## ***Interactive comment on “A centrifugal ice microtome for measurements of atmospheric CO<sub>2</sub> on air trapped in polar ice cores” by B. Bereiter et al.***

Received and published: 18 January 2013

The points mentioned by C. Stowasser are listed below. Each point is followed by our answer/editing.

Fig. 1.

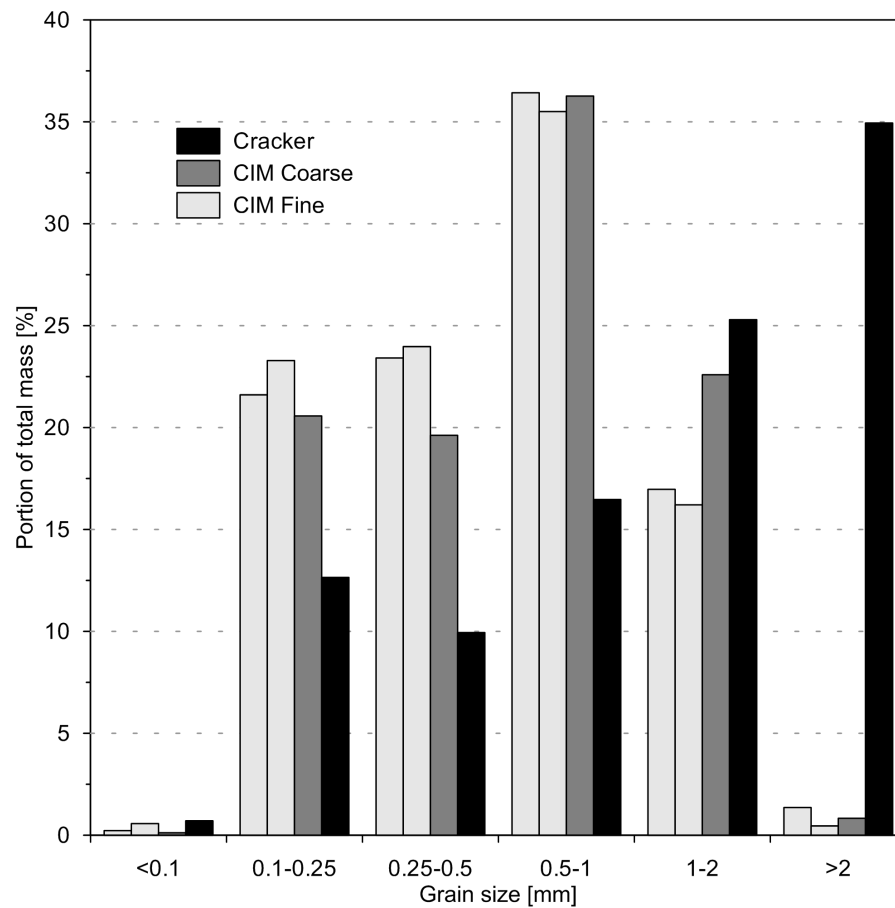
Figure 3: A grid in the background would help to read the portions easier.

We add a grid (see below).
